TILE ROOF WORKSHEET

re: Job 99237: SIMONS

Subject: Structural Investigation Report of the Roof for the Residence located at 83 Northlite Circle,
Sacramento, CA 95831.

ROOF PLAN - SIMONS

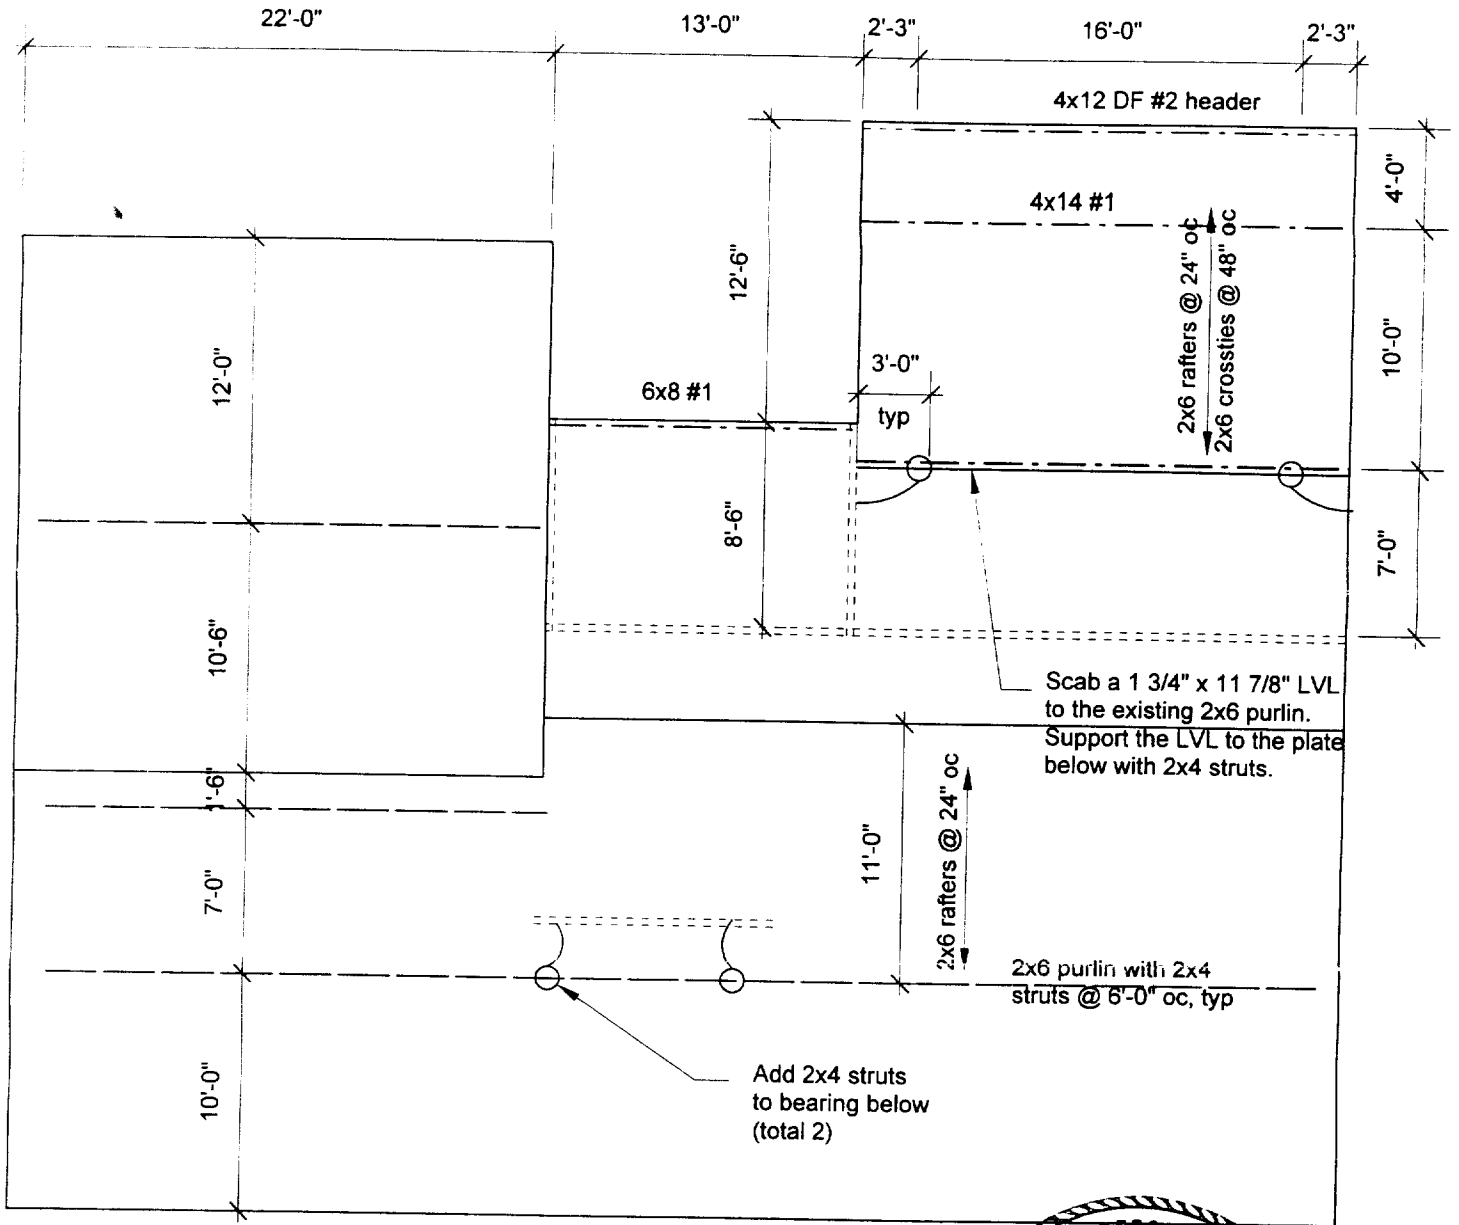
The living and garage areas lack sufficient structural capacity for the applied live and dead loads.

1. Provide additional 2x4 struts from the existing purlins to the bearing walls below. The maximum spacing between the new and existing struts shall not exceed 6'-0" on center. The unbraced length of the struts shall not exceed 8'-0" and the minimum slope of the struts shall not be less than 45 degrees from the horizontal. See detail 1.

2. Scab a 1 3/4" x 11 7/8" LVL beam to the existing 2x6 purlin and nail together with 16d's @ 12" oc. Support the LVL beam to the top plate below with 2x4 struts. See detail 1.
